UNITED STATES PATENT AND TRADEMARK OFFICE

APPLICATION NO.	FILING DATE	FIRST NAMED INVENTOR	ATTORNEY DOCKET NO.	CONFIRMATION NO.
10/801,844	03/16/2004	Thomas A. Follo	6579-0128-1	3109

DETAILED ACTION

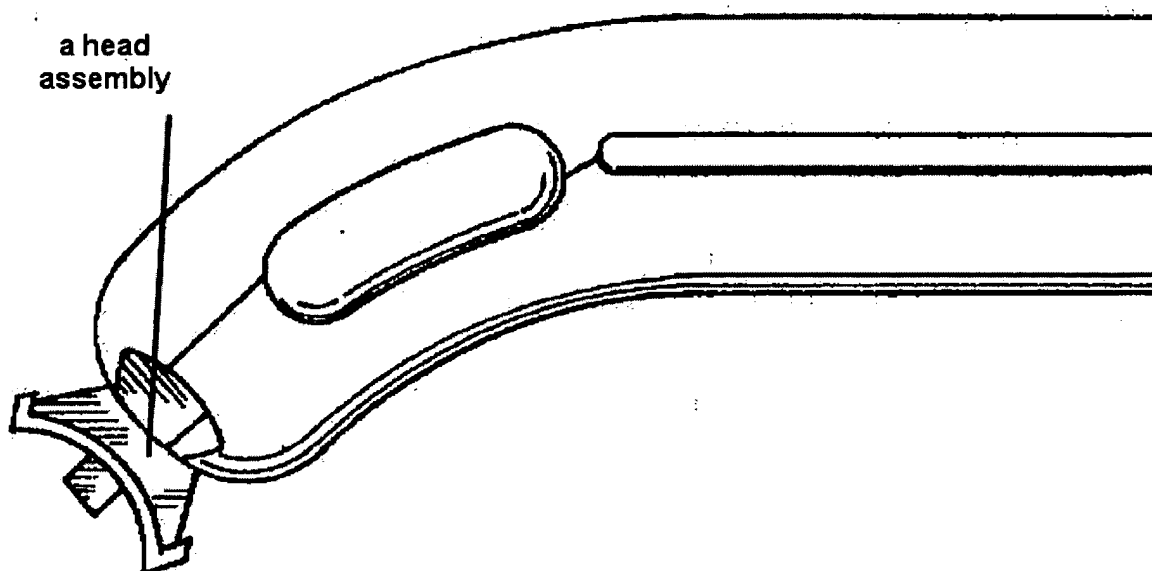
Regarding claim 10 Apprille discloses a razor handle assembly comprising: a first handle section having a first body portion (the area above 12 in fig. 2); a second handle section having a second body portion (the area below 12 in fig. 2), said first and second body portions being mirror images of one another; attachment means for coupling said first and second handle sections together (rivets, 18, figure 1), so that said first and second handle sections cooperate to form a closed end (the far right in figure 2) and an open end (far left: by the head assembly, figure 2) generally opposite said closed end; a head assembly (se figure below)

interposed between said first and second body sections at said open end, said head assembly defining means for releasably retaining a razor cartridge thereon (col. 3, lines 15-20); and a core interposed between said first and second body sections (figure 1, 12), said core having an end (figures 1 and 2, 12 is shown to extend to the closed end at the far right) adjacent said closed end and further discloses a razor handle wherein said core includes a first core section (figure 9) coupled to a second core section (figure 6). The two sections are coupled because the second core section is formed by being injected around the first core section as described in col.3 lines 55-67.
